Add new PSE MIB (Before 30.9.1.1.17) and reflect same in Table 30-4

Change the PD state diagram to the following:

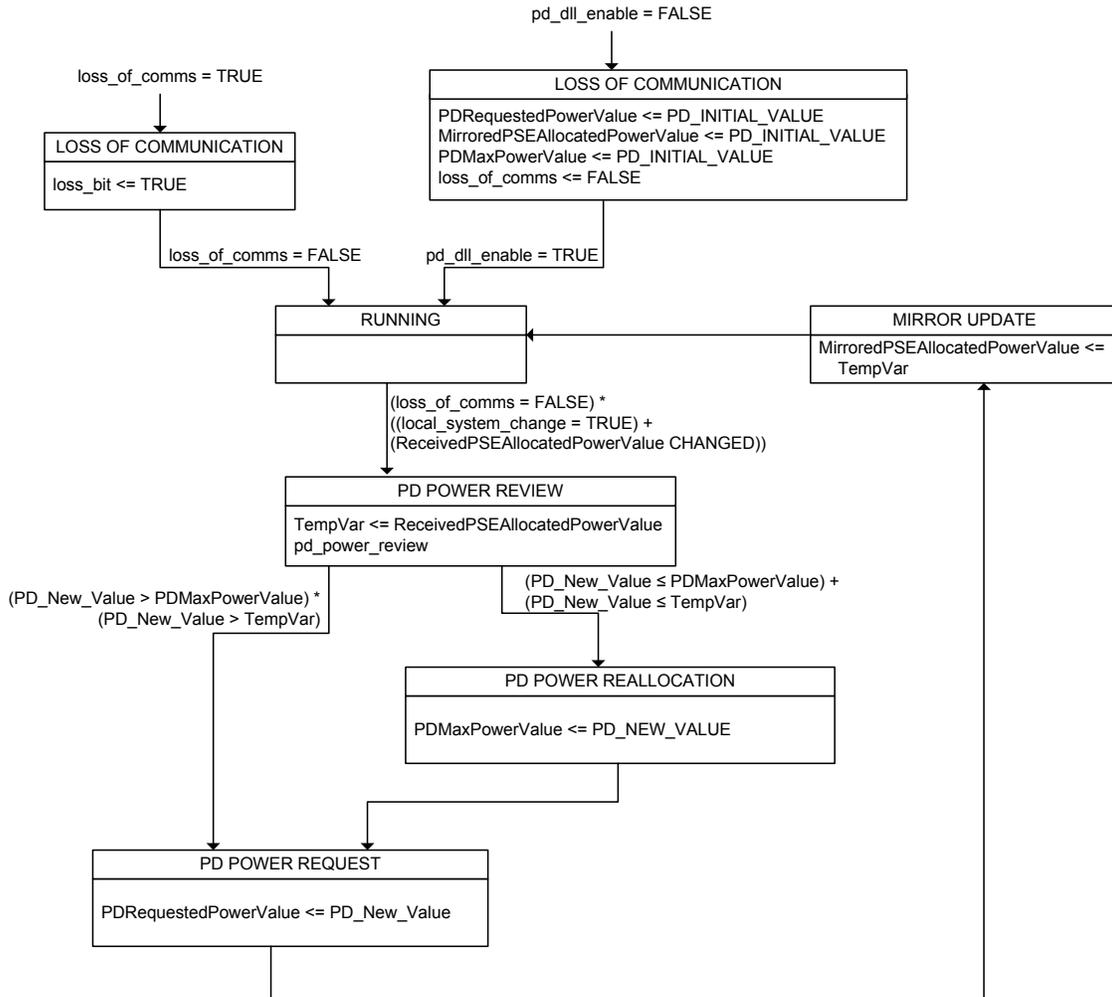
Replace Section 33.7.7.1

During normal operation the PSE machine is in the RUNNING state. If the PSE wants to initiate a change in the PD allocation, the local_system_change is asserted and the PSE enters the PSE POWER REVIEW state in the machine where a new power allocation value PSE_NEW_VALUE is generated. It then enters PSE POWER REALLOCATION state which causes the PSEAllocatedPowerValue to be updated to PSE_NEW VALUE. The machine then updated the MirroredPDRRequestedPowerValue in the MIRROR UPDATE state and then returns to the RUNNING state.

If the PSE machine sees a change to the previously stored ReceivedPDRRequestedPowerValue, it recognizes a request by the PD to change its power allocation. The PSE examines the request by entering into the PD POWER REQUEST state. The PSE may decide to ignore the request, in which case it returns to the RUNNING state or it may decide to change the PD allocation by entering the PSE POWER REALLOCATION state and behaves as described above.
